Subject: Ford Allen Park Clay Mine Land Ban No-Migration Petition

Subject: Petition for Exemption (Land Ban-K061)

Ford Allen Park Clay Mine Landfill

CONTAINMENT INTEGRITY OF ALLEN PARK CLAY MINE/LANDFILL

Figure 3. Solute efflux across aquitard into underlying aquifer as a result of salt water intrusion in overlying aquifer.

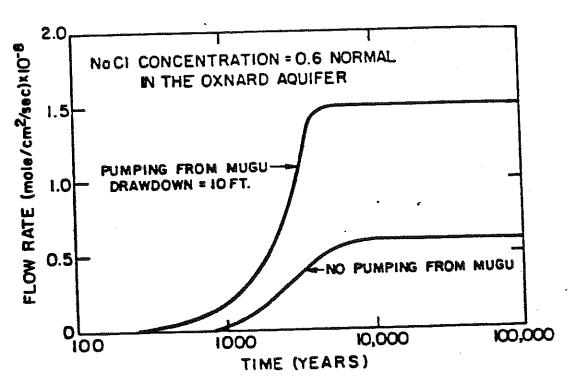
Results of the California study are presented in Figure 3 which shows the salt influx into the underlying aquifer as a function of time. Curves are presented for a no drawdown and 10-foot drawdown case (assuming the hydraulic gradient acts in the same direction as the salt concentration gradient). The horizontal portion of the two curves represents the steady state salt flux.

The main things to notice from this figure are the large breakthrough time (800 years) for the "no drawdown" case (i.e., in the absence of any hydraulic gradients) and the fact that in this aquitard the salt flux caused by drag coupling under a hydraulic gradient is larger. The steady state salt flux from the drag coupling under a combined 10-foot drawdown and salt concentration gradient is almost three times that from diffusion alone (no drawdown). Hence, in the event the hydraulic gradient was reversed, there would be no breakthrough and no downward salt flux provided the upward gradient exceeded about 0.2. In other words, under these conditions the two salt fluxes would be mutally opposed and exactly counterbalanced.
